CITY PLANNING COMMISSION
 1231 'I' STREET, SUITE 200, SACRAMENTO, CA 95814

- APPLICATION:
- A. Negative Declaration
 - B. Tentative Map to divide 1+ vacant acres into 12 townhouse lots and one common lot in the R-1A Zone.
 - C. Special Permit to develop 12 townhouse units in the R-1A Zone.

LOCATION: 4780 67th Street

COLONIAL VILLAGE TOWNHOUSES (P89-063)

TENTATIVE SUBDIVISION MAP
"COLONIAL VILLAGE TOWNHOUSES"

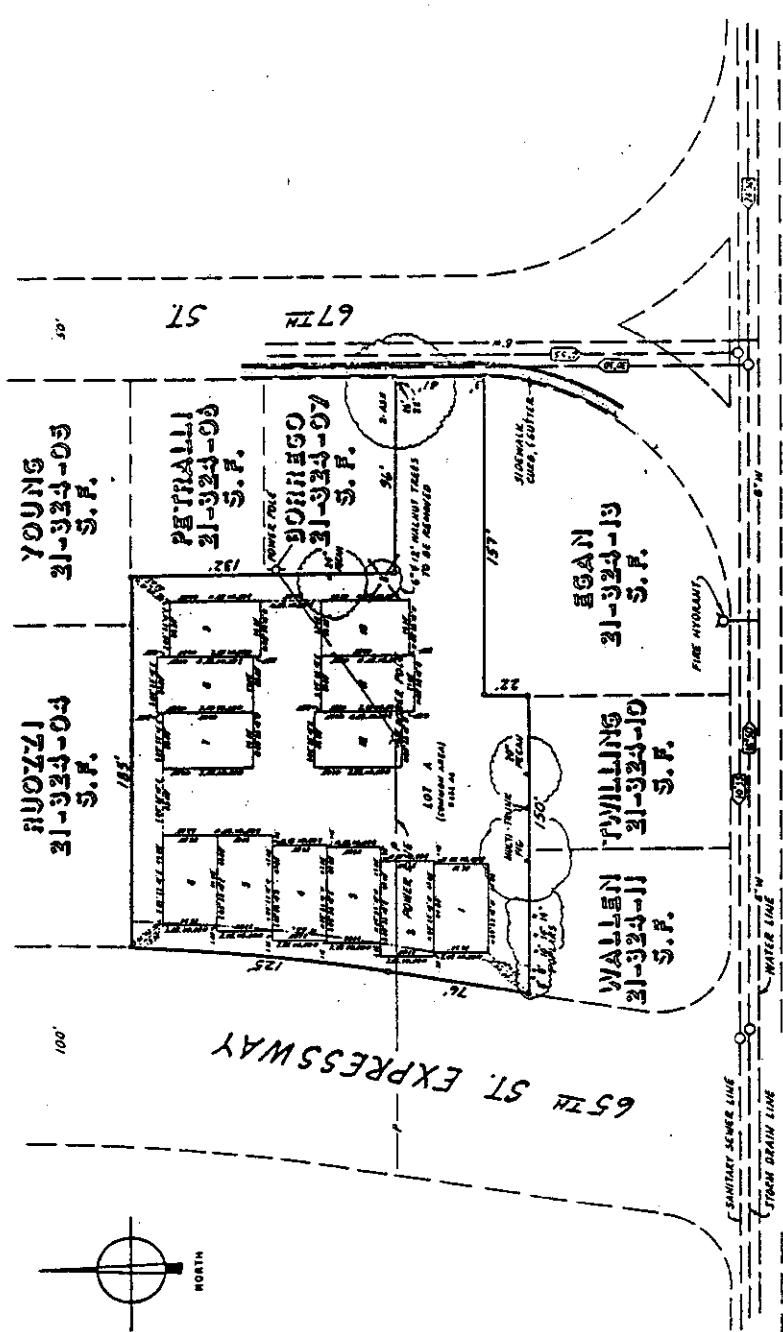
Plans for the project were routed to Traffic Engineering, Public Works and Police Departments. The Traffic Engineer request the driveway be 24 feet wide at the property line.

11. A eight foot high decorative noise barrier shall be constructed along the 65th Street Expressway frontage.

FIGURE 1

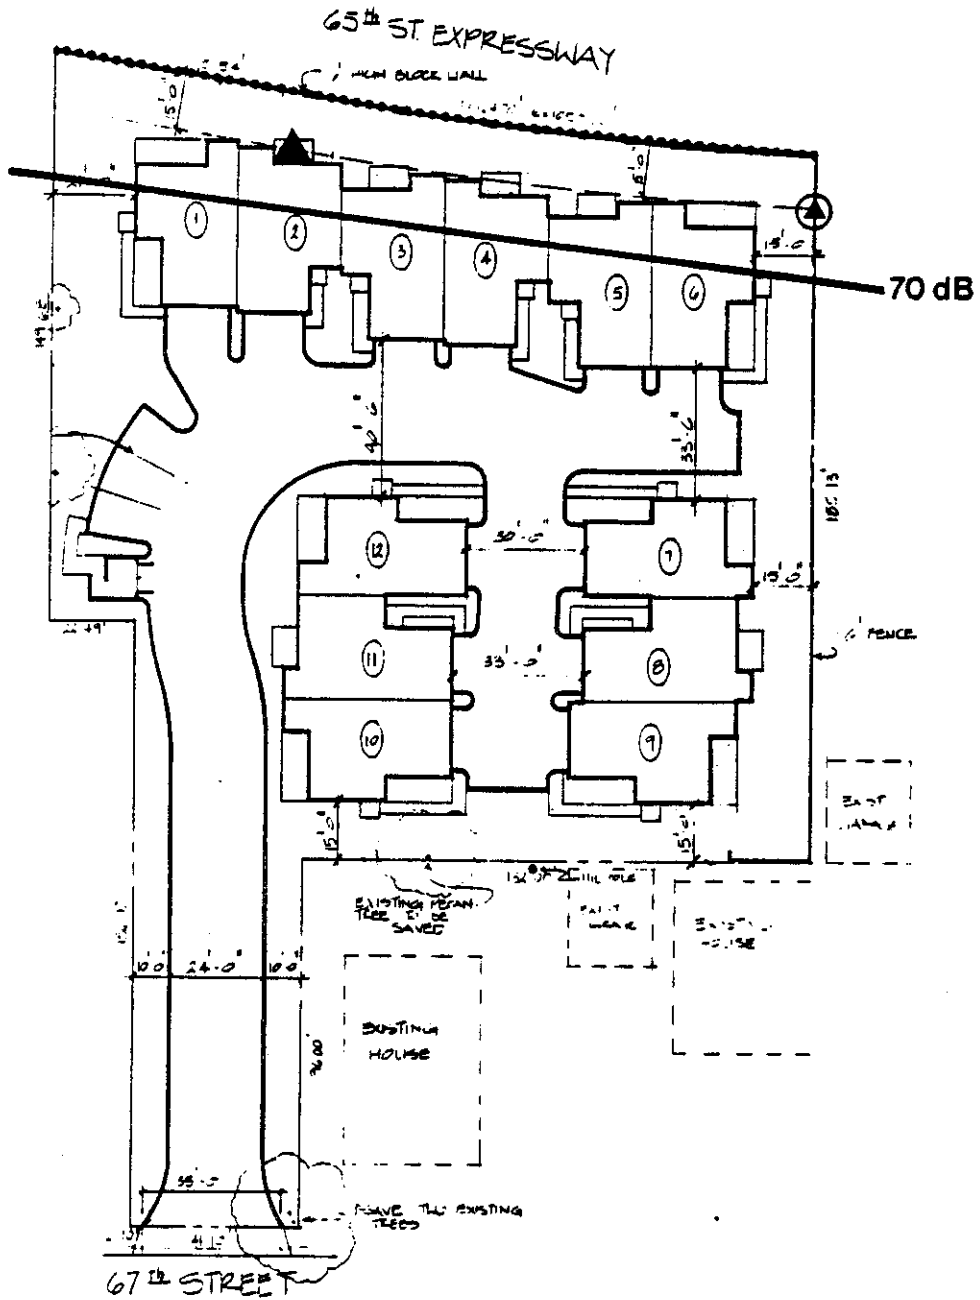
The results of the above analyses indicate that future exterior noise levels could be reduced to approximately 63 dB Ldn by providing a property line noise barrier 8 feet high. For this project, construction of the proposed property line barrier would be preferred for aesthetic reasons. The proposed property line barrier would provide visual continuity and would also result in larger outdoor activity areas. Although an 11-foot high barrier would be required to achieve an exterior noise level of 60 dB Ldn, an 8-foot barrier would be more feasible in terms of cost per residences shielded and would provide exterior noise levels of less than 63 dB Ldn.

- D. A property line noise barrier at least 8 feet in height shall be provided for patios the units located along the 65th Street Expressway as shown by Figure 1.

- E. Property line noise barrier materials must be airtight and massive, with no significant gaps in construction. Acceptable materials include masonry block, concrete panels, and 1-1/2" lumber with caulked overlapping joints.
